**SOUTH LAREDO LIFT STATION**  
**Solicitation Number: CO-00561**  
**Job No.: 22-2503**

**ADDENDUM 2**  
**June 27, 2022**

**SOUTH LAREDO LIFT STATION**  
**PROPOSED LIFT STATION PLAN AND SECTION VIEW**

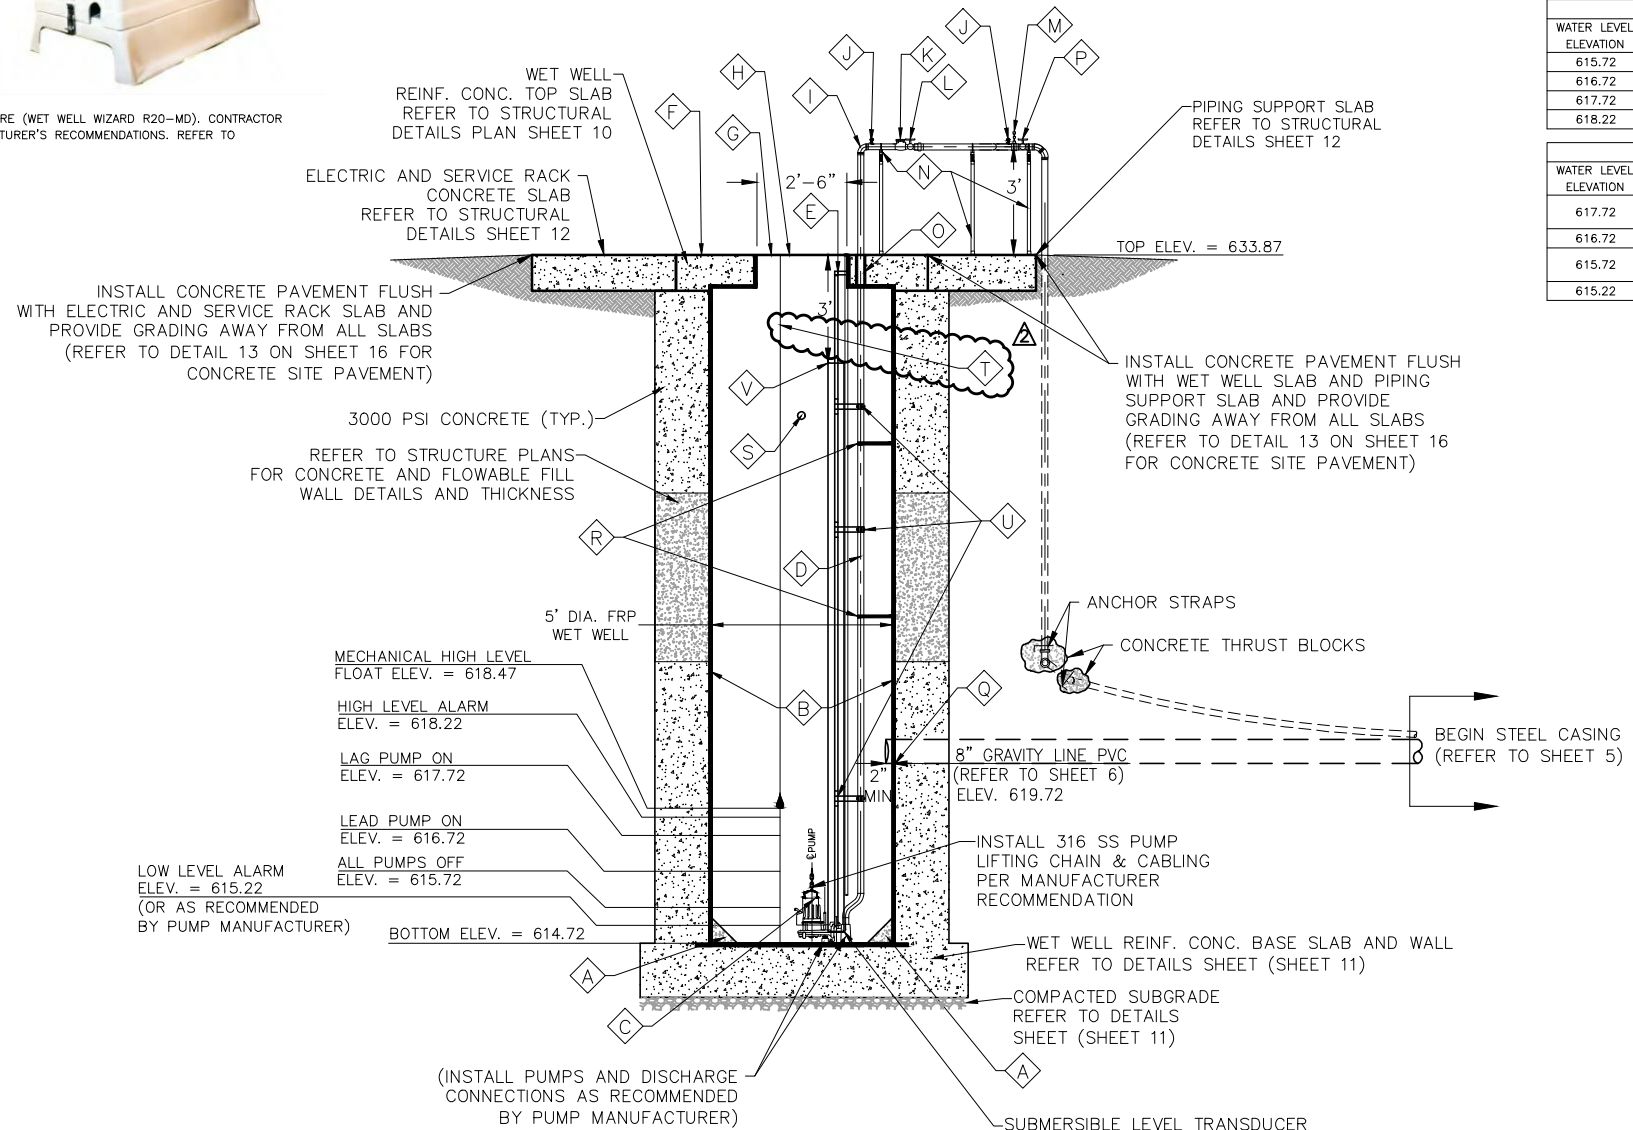
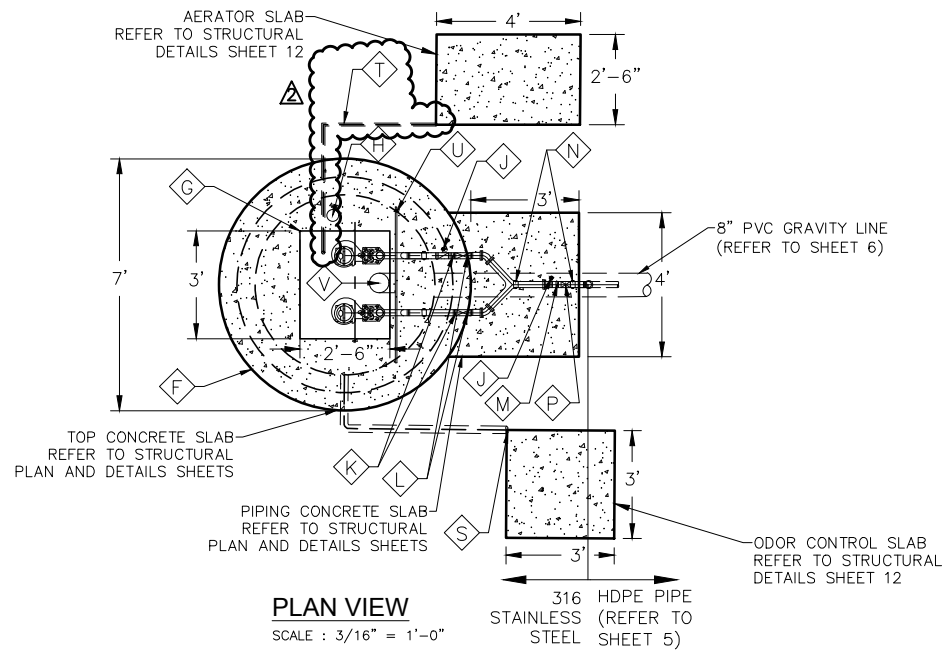
1. Contractor is to coordinate with Wet Well Wizard manufacturer for the location of the Wet Well Wizard inside the wet well. All accessories associated with the Wet Well Wizard, motor, hose, etc. shall be inclusive of Item No. 1 Lift Station lump sum.
